HISTORIC AND DESIGN REVIEW COMMISSION

August 07, 2019

HDRC CASE NO: 2019-409
ADDRESS: 818 N OLIVE ST
LEGAL DESCRIPTION: NCB 540 BLK 11 LOT A15
ZONING: R-5, H
CITY COUNCIL DIST.: 2
DISTRICT: Dignowity Hill Historic District
APPLICANT: Sue Ann Pemberton/Mainstreet Architects Inc.
OWNER: Jaqueline Roberts/BIGLEY RYAN
TYPE OF WORK: Exterior modifications, front porch modifications, window replacement, carport construction and accessory structure modifications
APPLICATION RECEIVED: July 18, 2019
60-DAY REVIEW: September 16, 2019
CASE MANAGER: Edward Hall
REQUEST:

SOUTH ELEVATION

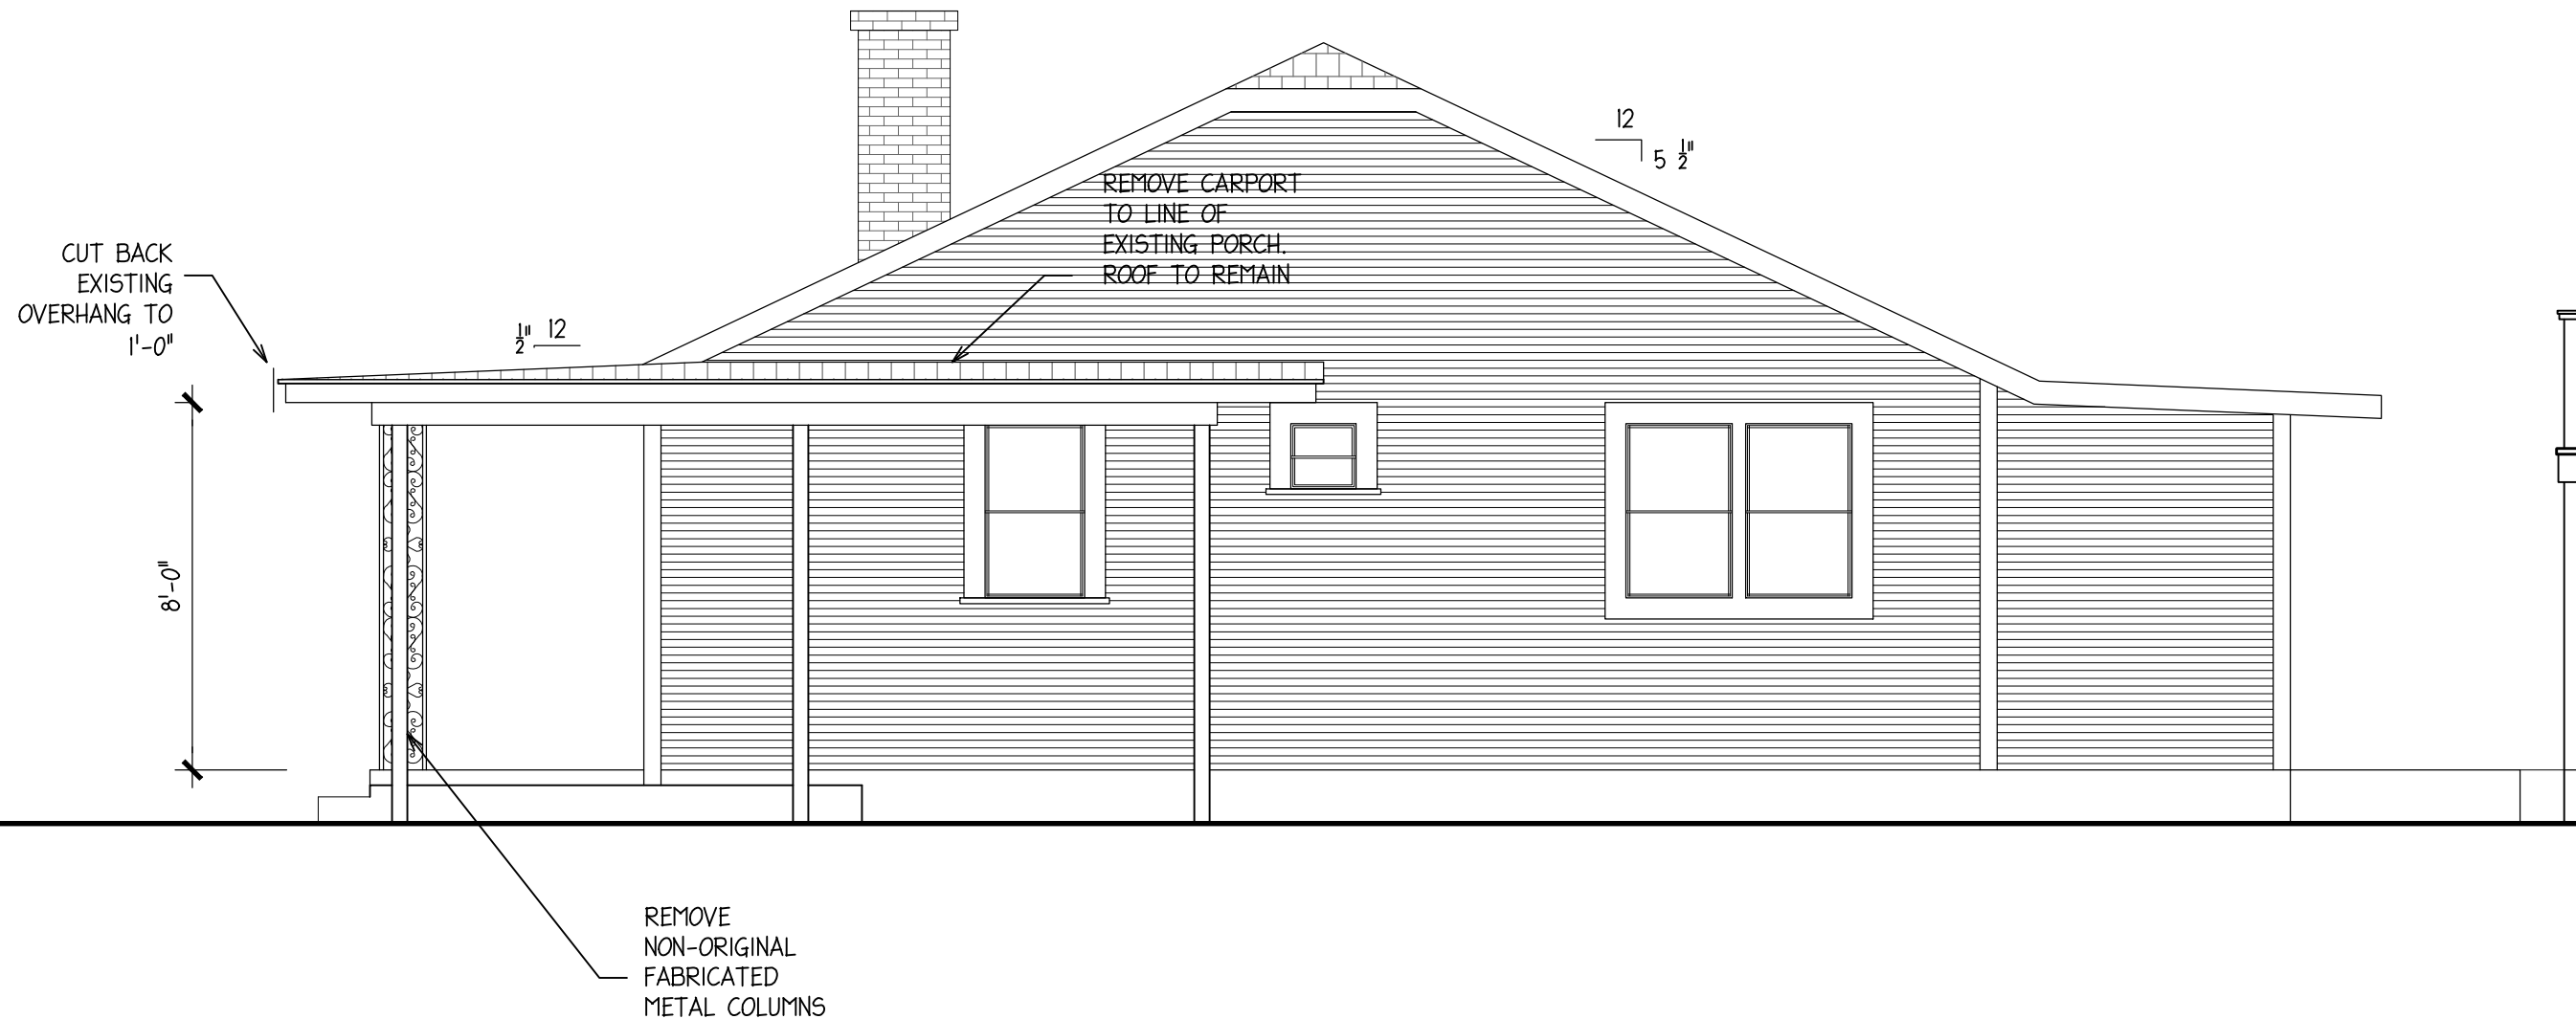
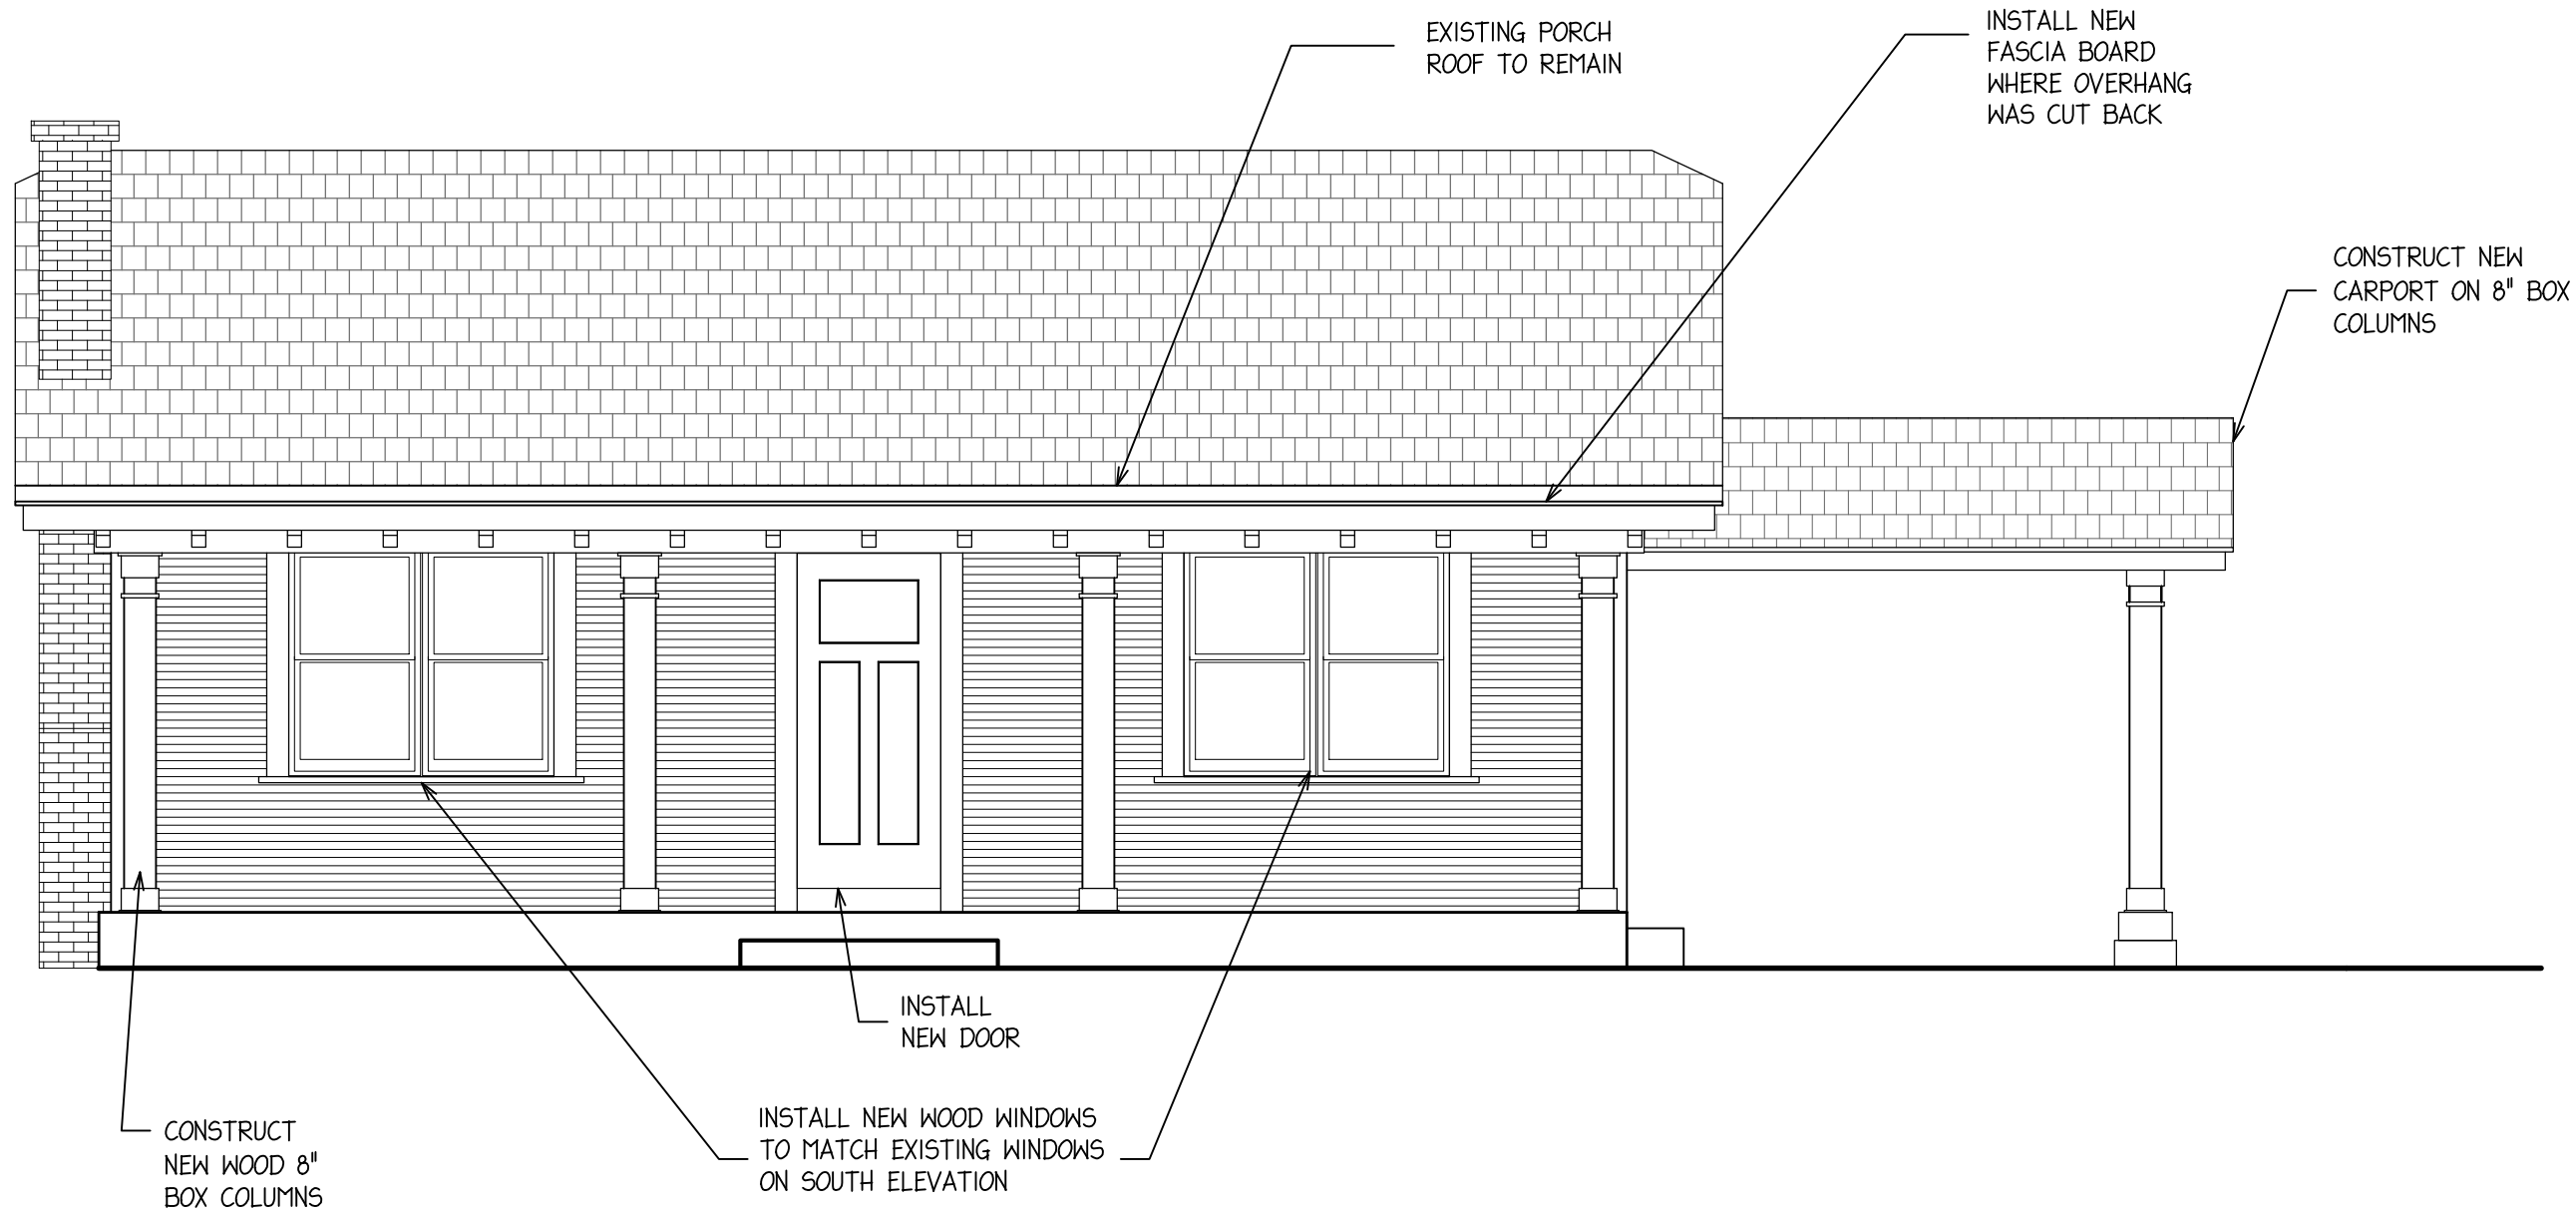
- b. CARPORT – The applicant has proposed to remove a non-original carport and construct a new carport on the south side of the historic structure. Currently, the existing carport and front porch act as one structure and read as one element. The applicant has proposed to separate the carport from the front porch and set it back from the front façade. The applicant has proposed materials that include eight inch square columns with capital and base trim, a shingle roof, and wood trim. Generally, staff finds the proposed carport removal and new construction to be appropriate; however, staff finds that the proposed carport should be detached from the historic structure.

- c. PORCH COLUMNS – The applicant has proposed to remove the existing, non-original wrought-iron porch columns and install eight inch square wood columns. The proposed columns are to feature both capital and base trim. Staff finds the proposed replacement to be appropriate.

- d. PORCH ROOF MODIFICATIONS – As noted in finding a, the original front façade and porch roofs have been modified. The applicant has proposed to modify the existing, non-original porch roof by removing a portion of the street facing overhang. Generally staff finds this to be appropriate; however, staff finds that architectural details and trim work should be simple in design as to not appear as original.

- i. That the applicant modify the design of the proposed carport so that it is detached from the historic structure.
- ii. That the proposed architectural details of the porch modifications be simple in nature as to not appear original.

GARAGE DECK

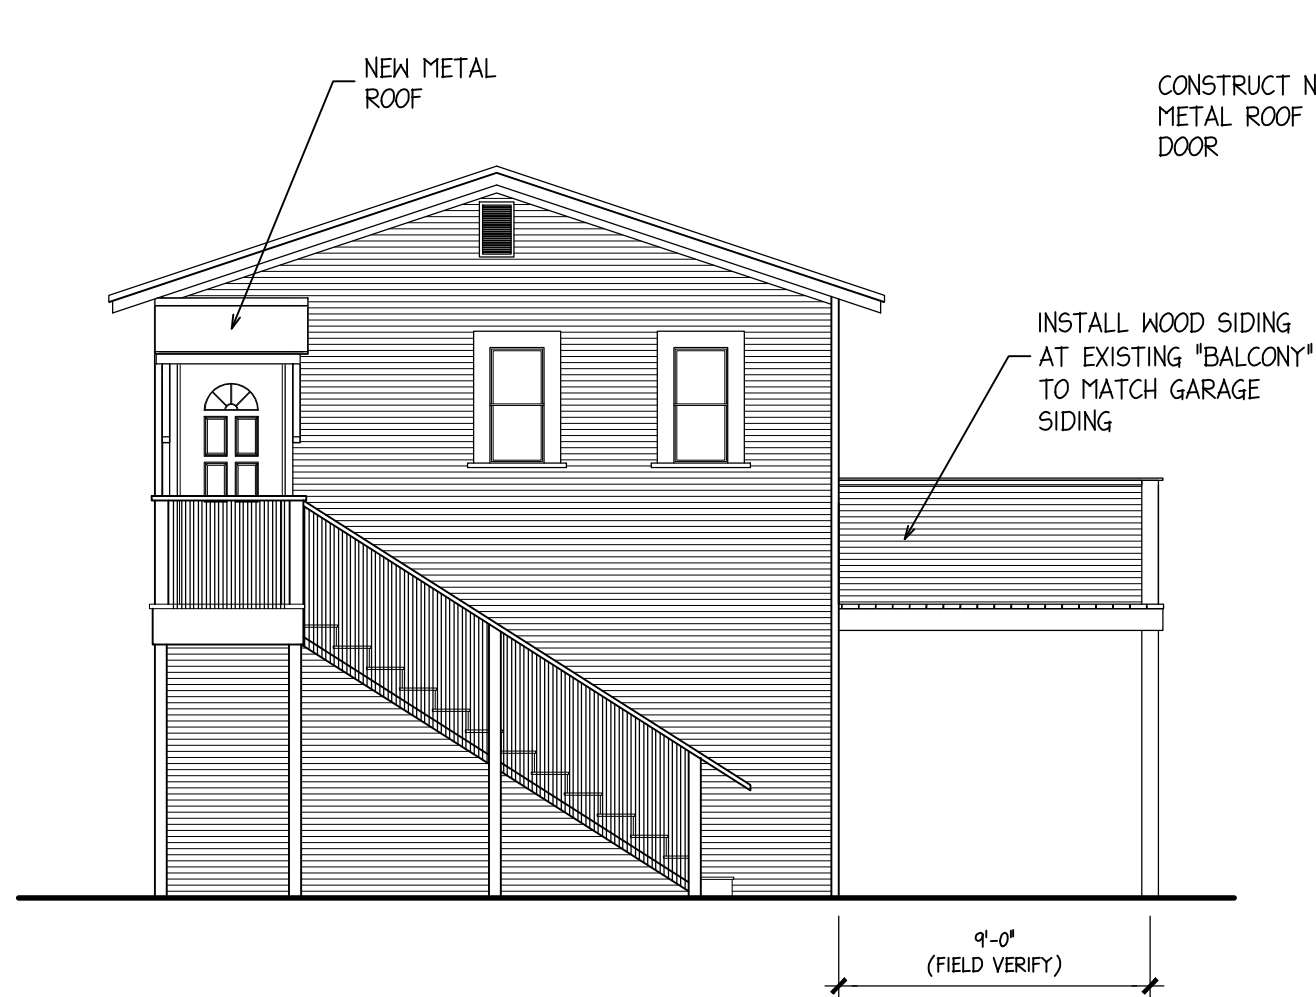
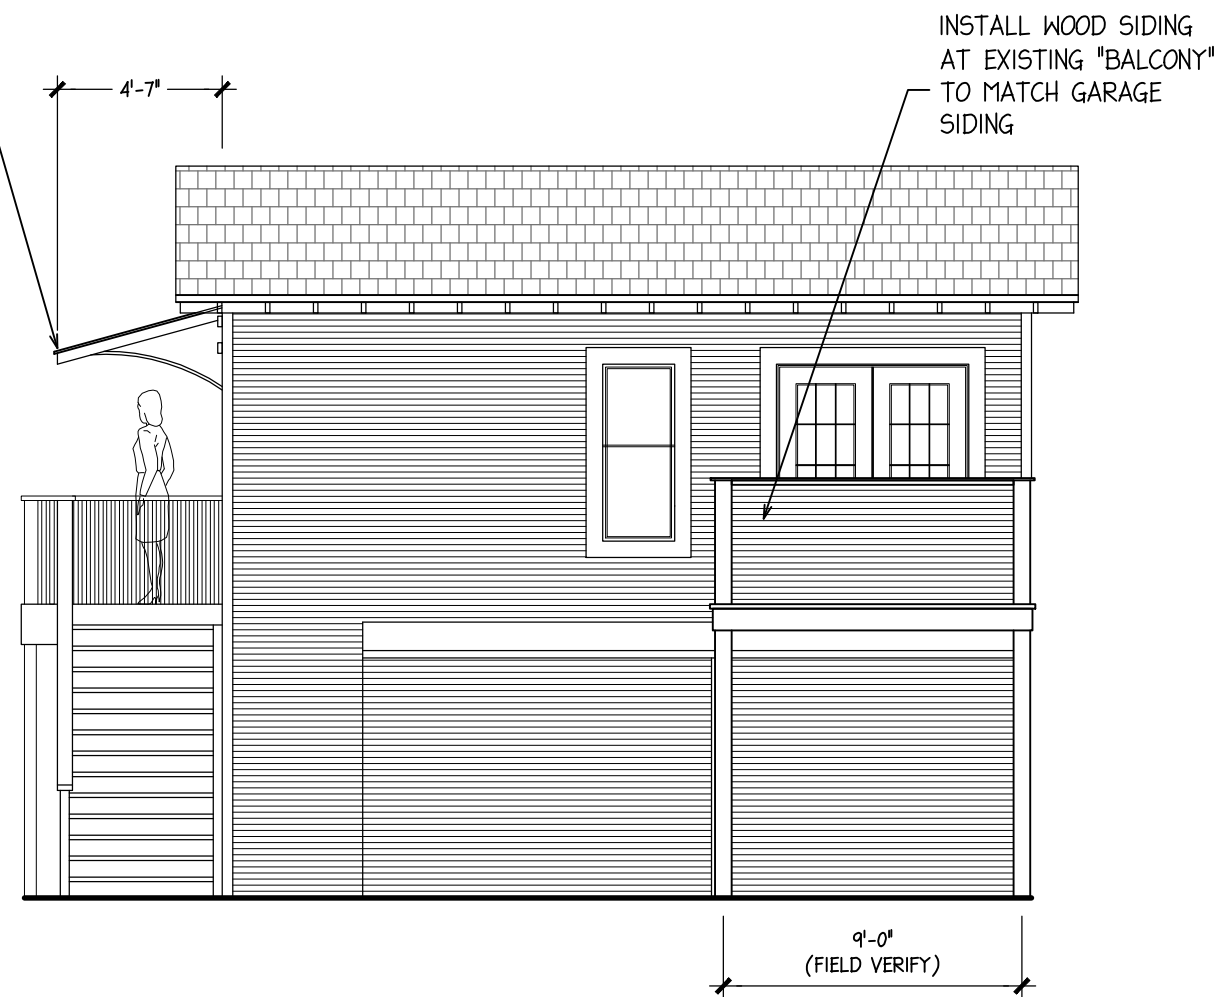
- h. ACCESSORY STRUCTURE ENTRANCE CANOPY – The applicant has proposed to install an entrance canopy over the second floor entrance of the rear accessory structure. This entrance faces the interior of the lot (north) and will feature a metal roof. Staff finds this to be appropriate.

- i. BALCONY MODIFICATION – The applicant has proposed to modify the existing balcony, which faces west, toward the rear of the primary historic structure. Within this modification, the applicant has proposed to decrease the balcony's footprint and install wood siding where previously railing existed. Generally, staff finds the proposed modification to be appropriate. The applicant has noted that the proposed siding is to match that
